Subject: Annual Inspection Report
Walker County – Bevill Field Airport (JFX)

**WALKER COUNTY AIRPORT
JASPER, ALABAMA**

Alabama Department of Transportation Aeronautics Bureau—Annual Airport Inspection Report

WALKER COUNTY AIRPORT
Jasper, AL
February 8, 2023
Runway 9 Obstruction Evaluation

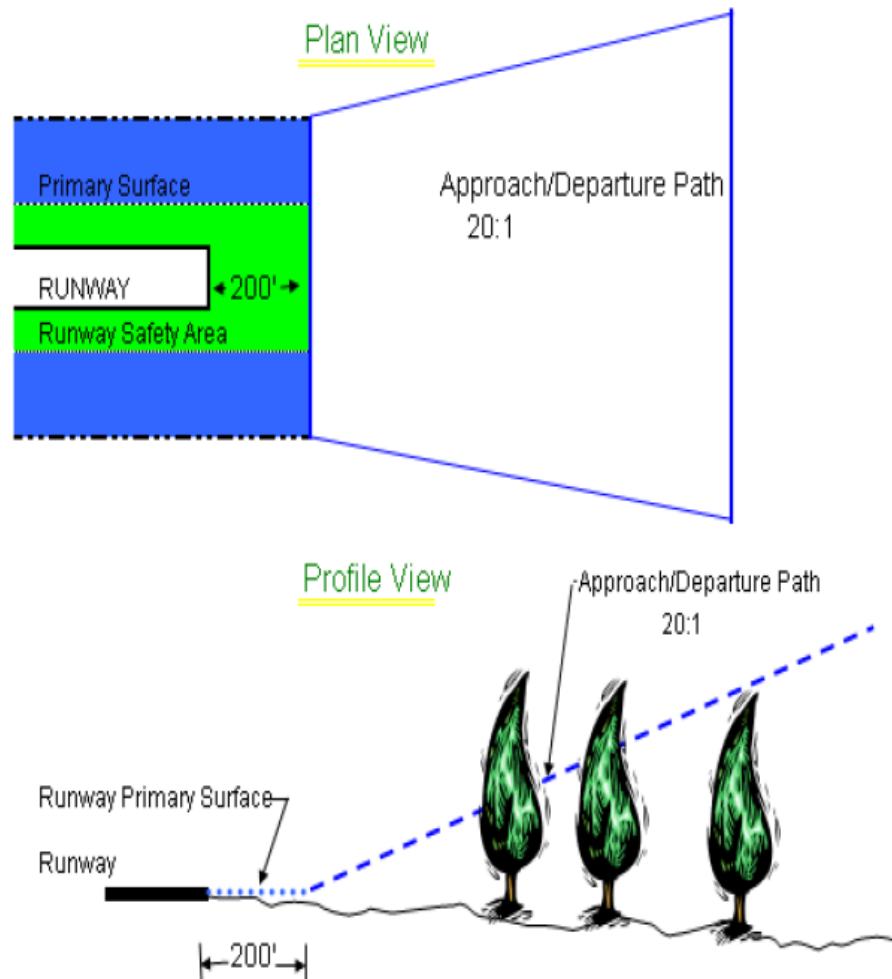
VIOLATION: Tree Group #1 is in the ALDOT 20:1 Approach/Departure path. Please review appendix #2 for more information.

1. Tree 24' Abv. Rwy
559' From Rwy End
113' Left of CL
15:1 Obst. Clrnc

ALDOT 20:1 Violation
 Controlling Obstruction

Aeronautics Administrative Code	Inspection Results	Corrective Action	Notes
Approach & Departure Paths Administrative Code 450-9-1-.12 (1)	<i>Violation</i>	Remove the trees noted in the report off of Runway 09.	The tree group in violation was noted in 2020. Please see appendix #2.
Primary Surface Administrative Code 450-9-1-.12 (2)	<i>In Compliance</i>	N/A	N/A
Runway Safety Area Administrative Code 450-9-1-.12 (3)	<i>In Compliance</i>	N/A	N/A
Airport Markings Administrative Code 450-9-1-.12 (4)	<i>In Compliance</i> <i>Maintenance</i>	Runway markings should be cleaned. White Taxiway centerline needs to be removed and marked in accordance with AC 150/5340-1M.	Runway and taxiway markings are in poor condition. Taxiway centerline markings must be yellow.
Wind Direction Indicator Administrative Code 450-9-1-.12 (5)	<i>In Compliance</i>	N/A	N/A
Airport Lighting Administrative Code 450-9-1-.12 (6)	<i>In Compliance</i> <i>Maintenance</i>	Replace inoperable lighting.	Six taxiway lights out in a row.
